**Questions in Response to RAI 8089, Question 03.11-11**

The remaining questions are all regarding the proposed markup to APR1400-E-X-NR-14001-P (Attachment 2 in the response).

Figure 1. Locations of Dose Points for TID calculation inside Containment

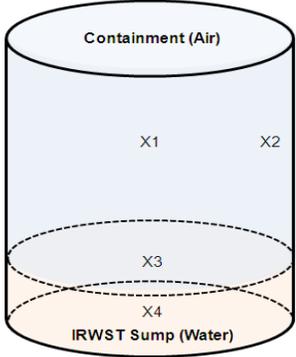
7. In Section 3A.1, the applicant indicates that the dose rate was calculated at the containment atmosphere, containment wall surface, bottom of containment, and in the center of the containment IRWST sump. However, the markup does not specify why these locations were chosen and how the doses from these four locations were used to come up with the TID for components in containment (for example, were all four doses added to come up with a TID value to be used for all components in containment, or how were the individual dose rates assigned to specific equipment).

(KHNP Response) As shown in Figure 1, the four locations evaluated were determined taking into account the installation locations of the components and equipment inside the containment.

The TIDs for each of the components/equipment at these locations, which are calculated using the RUNT-G code, are as follows:

Depending on the location, the resultant TIDs assigned to specific components or equipment were determined for the bounding analysis as follows:

- Components located Above Elevation 100' = TIDs at X4 location
- Components located Below Elevation 100' = Maximum gamma TID + Maximum beta TID at any location (i.e., Gamma TID at X3 location + Beta TID at X2 location)
